MerCruiser

Bulletin No. 2002-04

▲Required 496/8.1S Water Rail Parts Replacement

- a** - Water Rail Snout
- b** - Water Rail Connector
- c** - Hose Bib Fitting

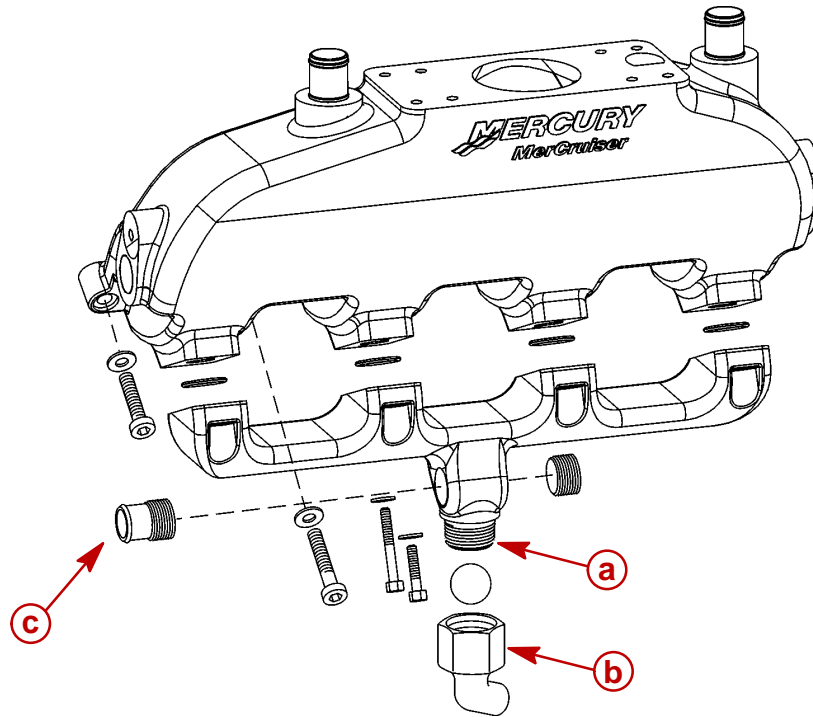
Under certain circumstances, corrosion to the aluminum water rail may occur at the brass fitting locations. This is more likely to occur when the boat is used in salt water, brackish water, or water with a high mineral content.

1. Remove the water rail connector and the hose bib fitting from both water rails on the engine.

2. Inspect the threaded snout of the water rail and the hole in the water rail that held the hose bib fitting for severe damage due to corrosion.
 - On the water rail snout, severe corrosion damage is defined as damage that extends all the way around the snout or more than 1 full thread deep at any one location on either water rail snout.
 - In the hole for the hose bib fitting, severe corrosion damage is defined as damage that leaves less than 3 full undamaged threads.
3. Based on the results of your inspection, proceed as follows:
 - No severe damage found – Water rails should continue to be used. The water rail connector and the brass hose bib fitting must be replaced on both water rails on the engine. Order one Water Rail Connector & Fitting Kit per engine.
 - Severe damage present – Both water rails must be replaced. Order one Water Rail Replacement Kit per engine.

Qty 1	P/N 863116A1	Water Rail Connector & Fitting Kit
Qty 1	P/N 862992A1	Water Rail Replacement Kit
